ISO/IEC JTC 1/SC 2 N 3514/ W G 2 N 2328

DOC TYPE: Summary of Voting/Table of Replies

TITLE: Summary of Voting on SC 2 N 3503, ISO/IEC 10646-1: 2000/PDAM 1,

Information technology -- Universal Coded Character Set (UCS) -- Part 1: Architecture and Basic Multilingual Plane AMENDMENT 1: Mathematical

Table 70 (74)- Row 26: Miscellaneous Symbols

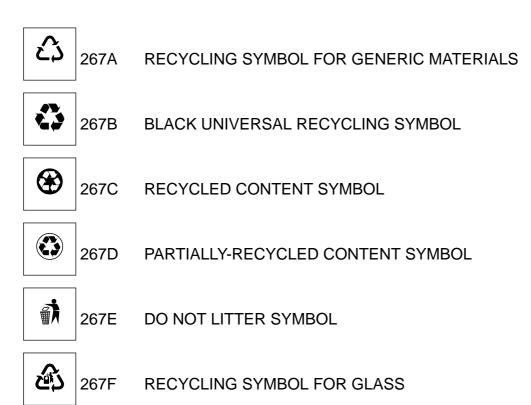
Six additional characters should be added to the standard at this time to fill out the set of recycling symbols, as discussed in N2310R. Proposed names, glyphs, and code positions are as follows:
